Review Assessment

Wilmington Harbor, North Carolina
Navigation Improvement Project
Integrated Section 203 Study & Environmental
Report
(February 2020)

May 2020

Figure 9-2
Variability of Mean Tidal Range Based on Annual Data

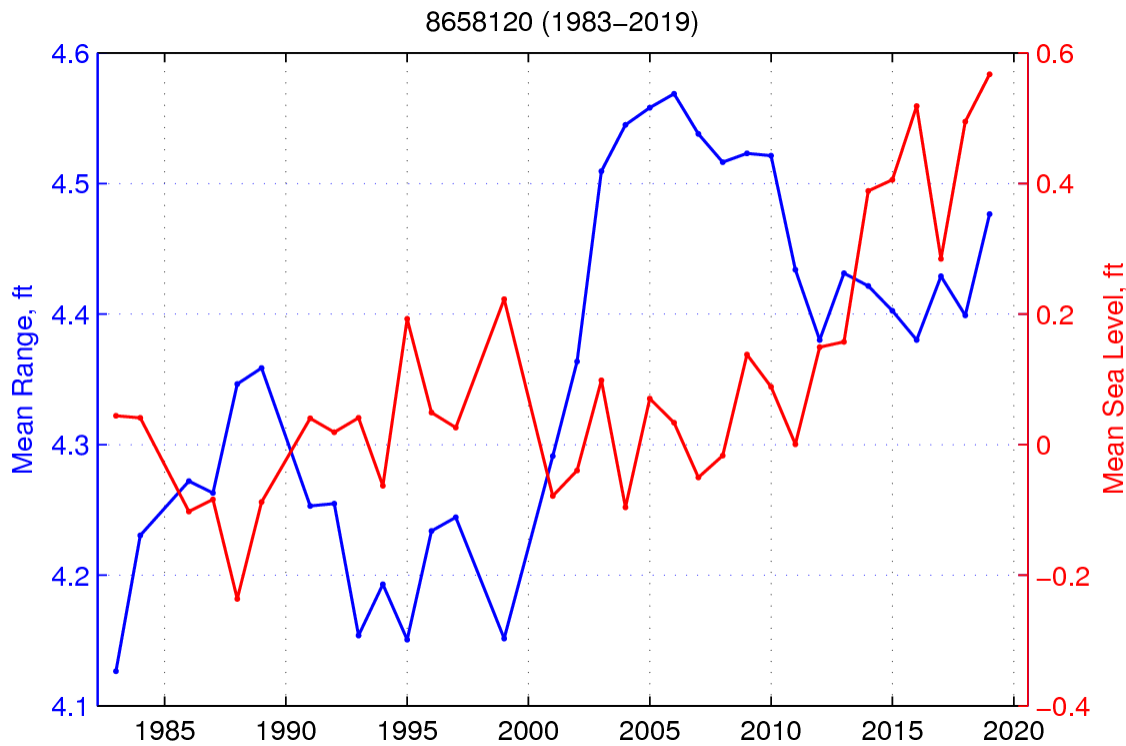
OASACW/HQUSACE Final Assessment: The comment is unresolved. In particular, the response states that “The change in tidal range is not due to climate effects, but rather due to the alteration of the Cape Fear River Estuary by federal navigation projects over the past 150 years. Thus, this trend in MHHW (and tide range) should not be expected to continue in the future in the absence of any future navigation projects and should not be used as the future sea level for the FWOP and FWP conditions.” In fact, this project will exacerbate the situation by deepening the channel further with potential nonlinear increases in tidal prism upstream. Risks to shoreline development, bridge clearance, if any, coastal flood risk reduction measures, if any, and the performance of gravity drainage infrastructure, should be addressed. . Where these systems were federally-funded in whole or in part, this project cannot reduce their design performance. A description of the potential issues and any necessary adaptation measures is sufficient.

As shown in Table 9-5 and Figure 9-2 the rate of increase during the aforementioned time periods for MHW and MLW is similar to the rate of increase of MSL. Specifically, it was observed that MHW is increasing at a slower rate (by 15–20%) than MSL during the periods when no major alterations were made to the river channel.

Table 9-6 shows a notable change in the mean tide range as a result of the channel improvements that occurred between 2000 and 2004. This is especially clear in Figure 9-2 based on yearly data. Figure 9-2 a significant but gradual increase in the tidal range which occurred between 2000 and 2004 due to the most recent channel deepening / widening project.
